**City of Bellevue
Development Services Department
Land Use Staff Report**

Proposal Name: Tse Patio

Proposal Description: Land Use review of a patio and block walls within a 50-foot top-of-slope buffer from a steep slope critical area associated with code enforcement 11-122443-EA.

File Number: 11-130705-LO

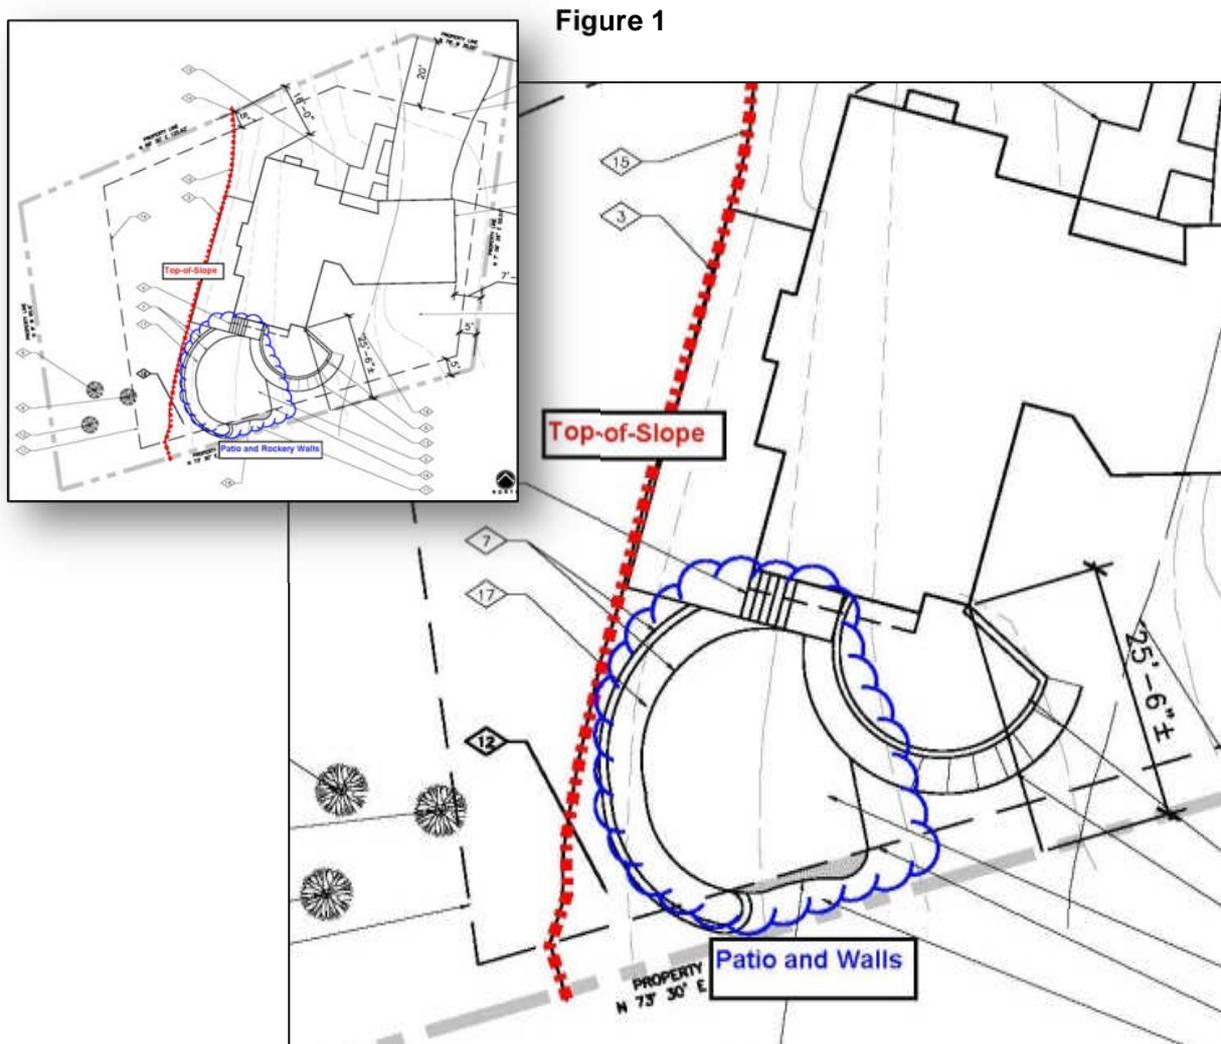
The applicant constructed a circular patio and 2 terraced block walls within the 50-foot top-of-slope buffer from a steep slope critical area. The improvements modify approximately 600 square feet of slope buffer immediately above the top-of-slope. A Critical Areas Land Use Permit is required to approve reduction of the buffer for the patio and walls. See Figure 1 below and Attachment 1 for a project site plan.

**Attachment 1:
Site Plan**

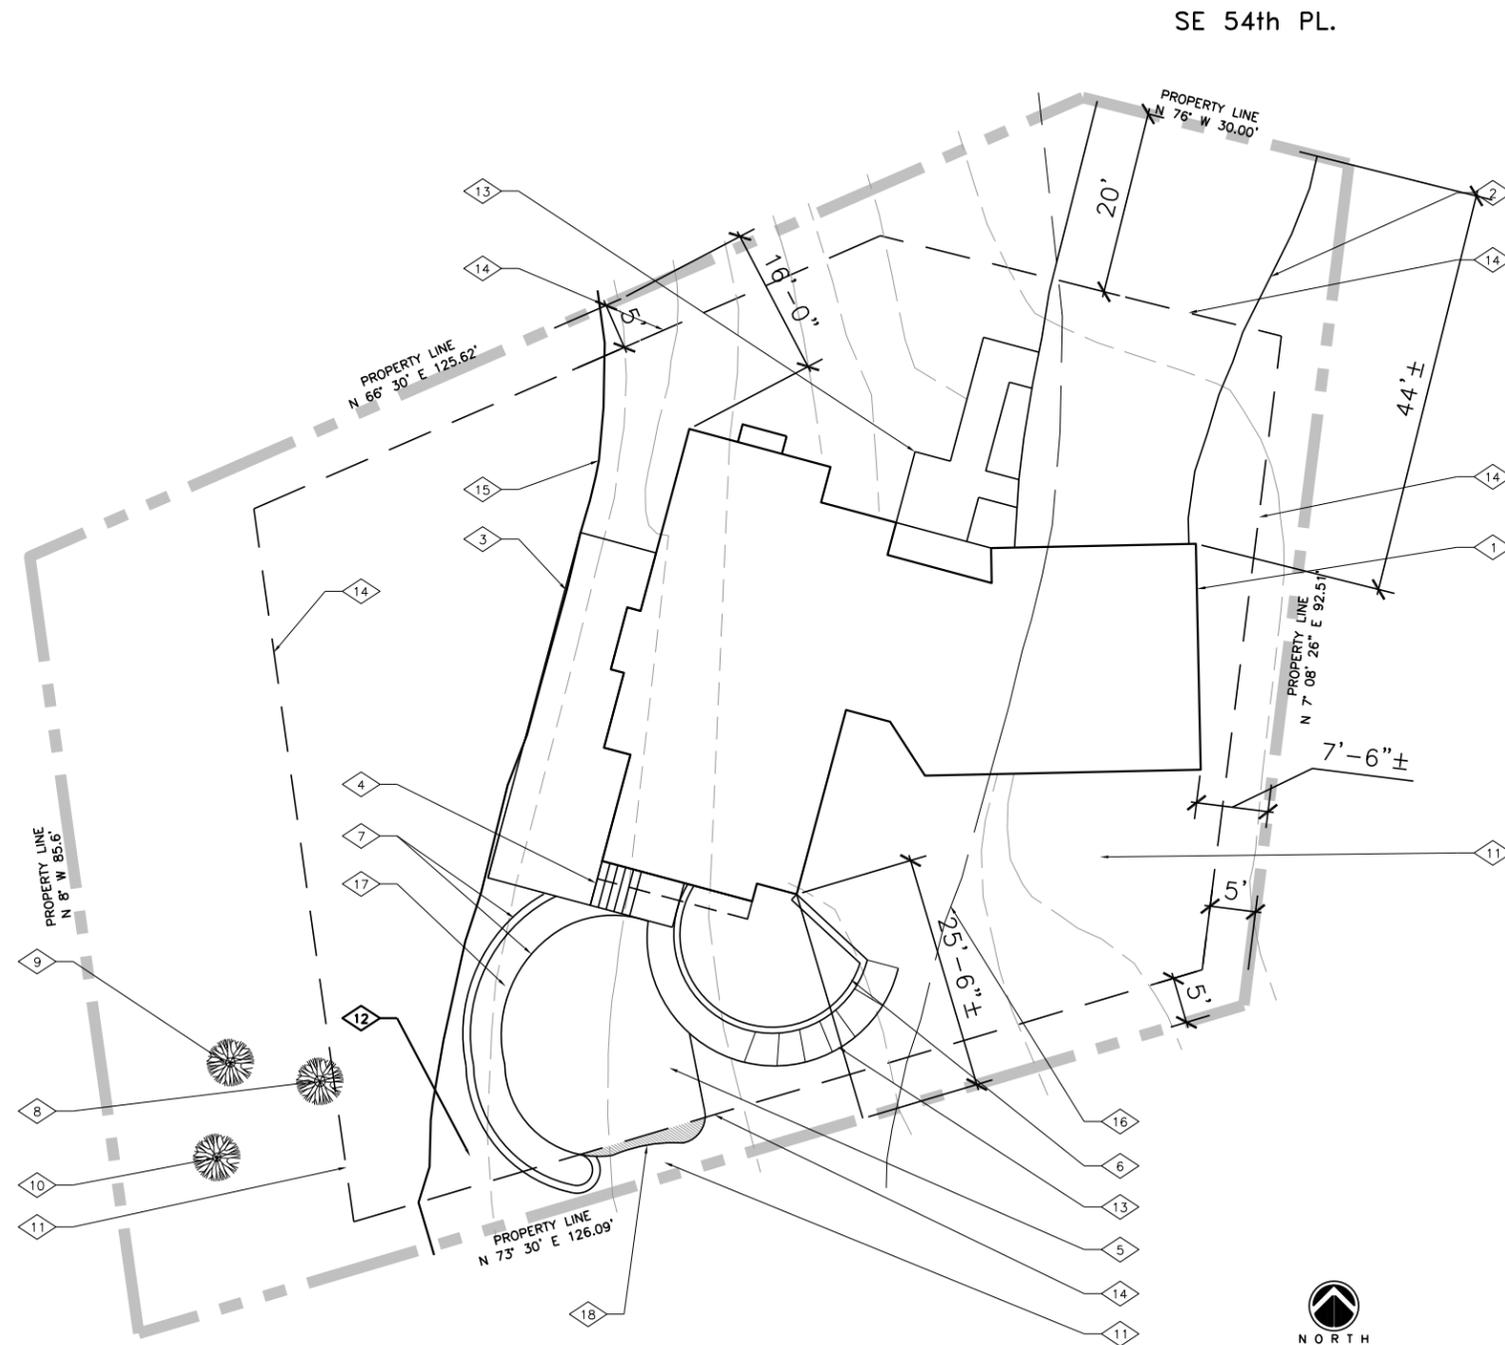
Staff has required additional mitigation planting in order to demonstrate the required improvement of steep slope critical area functions. The planting is required to be shown on the plans submitted with the clearing and grading permit. Staff has also required the heights of the walls to be shown on the plans, measured from finished grade to confirm that no walls greater than 30 inches are located in a required setback. Staff has also required that the required 5-year monitoring include the submittal of an annual report with photos to document plant growth.

- 2. Block Wall Height Verification:** The plans submitted with the clearing and grading permit must show the top and toe elevations of the wall so that the height can be determined. No wall is allowed in a structure setback which is greater than 30 inches in height measured from finished grade.

- 3. Mitigation Planting Plan:** At least 600 square feet of area on the slope, below the walls is required to be planted in exchange for the reduction of the slope buffer. The planting shall include at least 38 shrubs. Additional shrubs can be installed in lieu of ground covers, but the 600 square feet must have a sufficient plant density with shrubs spaced 4 to 6 feet on-center. The planting area and plants are required to be shown on the plans submitted for the clearing and grading permit. Plants must be native and can be selected from the City's planting templates for steep slopes or as recommended by a qualified specialist.

- 7. Photo Monitoring Locations:** The locations where photos will be taken to monitor the planting must be shown on the site plan for the clearing and grading permit. The locations shall also be marked in the field with stakes to ensure easy location recall over the monitoring period.
